PROPOSED TECHNICAL SPECIFICATION REVISIONS
BROWNS FERRY NUCLEAR PLANT
(TVA BFNP TS 191 SUPPLEMENT 1)

DESCRIPTION AND JUSTIFICATION AND SAFETY ANALYSIS
(TVA BFNP TS 191 SUPPLEMENT 1)

Response to NRC Request for Additional Information, dated January 23, 1984,
"Reactor Vessel Pressure - Temperature Curves"

Figure 3.6-1

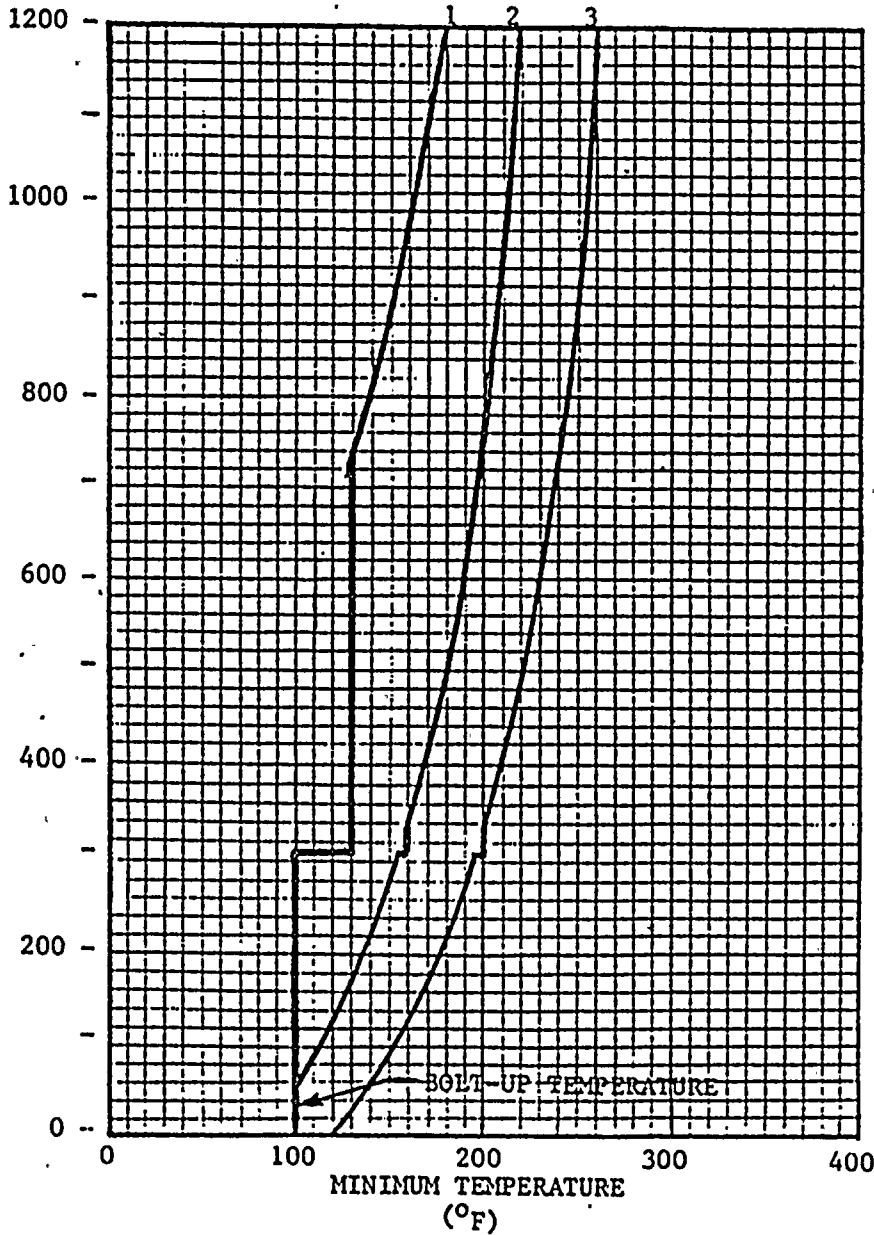
These curves include sufficient margin to provide protection against feedwater nozzle degradation. The curves allow for shifts in RTNDT of the reactor vessel beltline materials to compensate for radiation embrittlement for 12 EPFY.

Revise figure 3.6-1 to reflect shifts in RT_{NDT} of the reactor vessel
beltline materials to compensate for radiation embrittlement for 12 EFPY.

Consequently revisions to Figure 3.6-1 have been provided which supercede all curves previously submitted by TS 191.

Figure 3.6-1

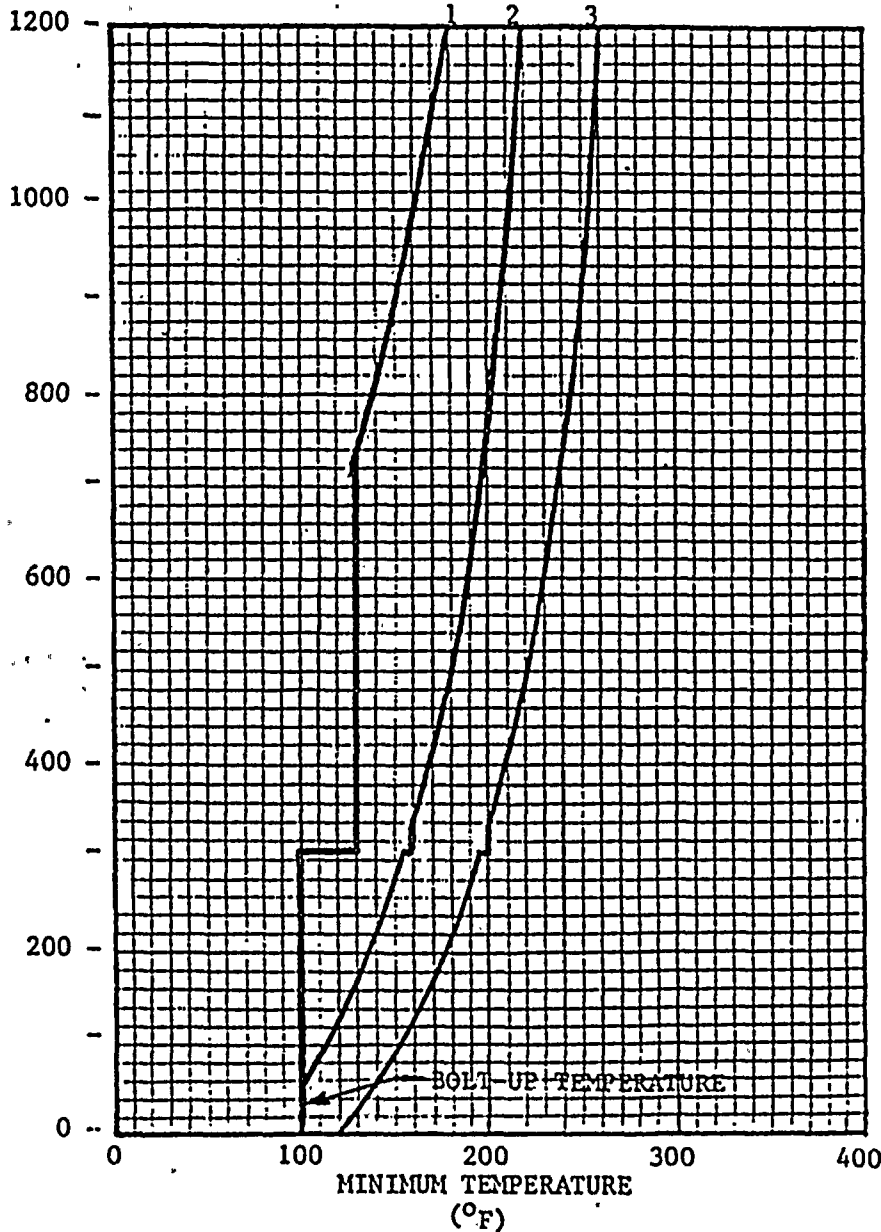
These curves include sufficient margin to provide protection against feedwater nozzle degradation. The curves allow for shifts in RTNDT of the reactor vessel beltline materials to compensate for radiation embrittlement for 12 EFPY.

Figure 3.6-1

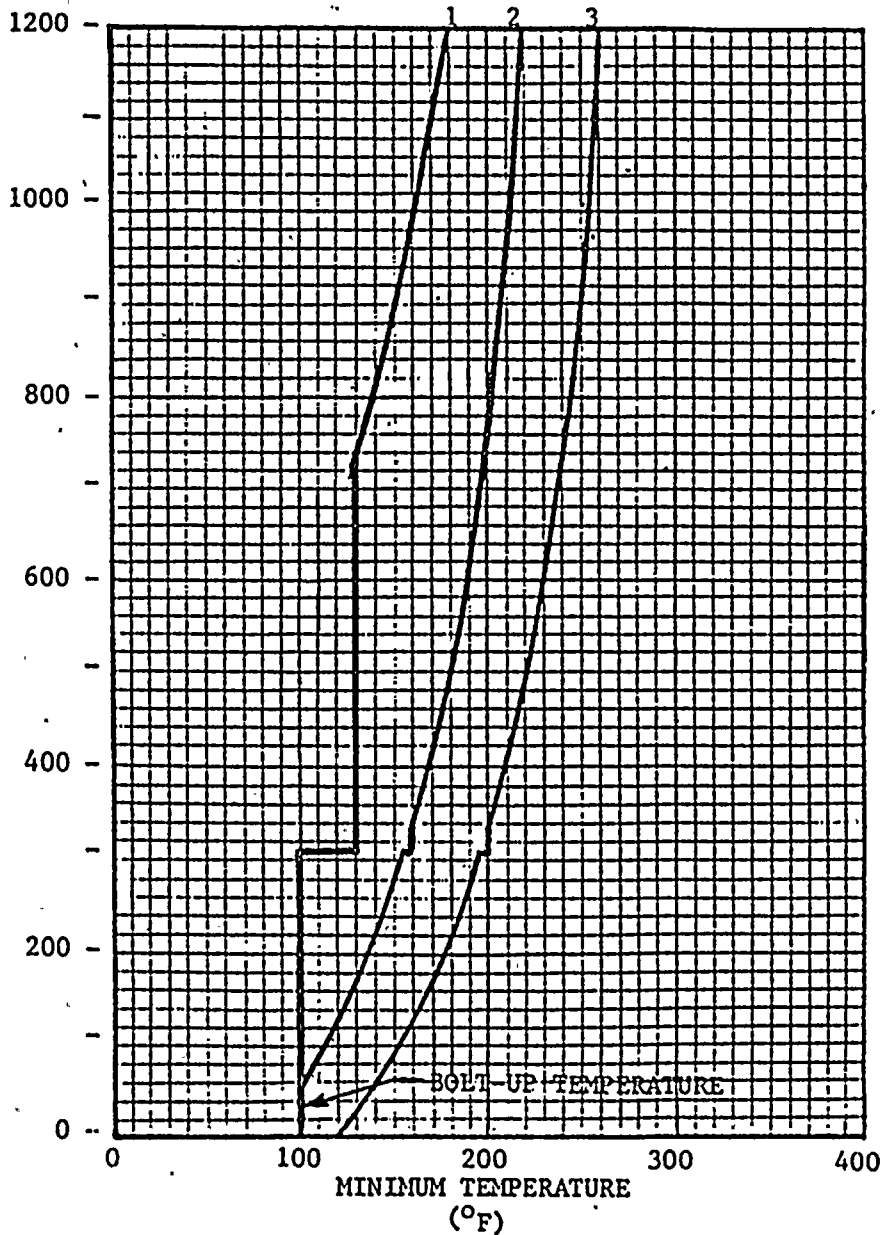
These curves include sufficient margin to provide protection against feedwater nozzle degradation. The curves allow for shifts in RTNDT of the reactor vessel beltline materials to compensate for radiation embrittlement for 12 EFPY.
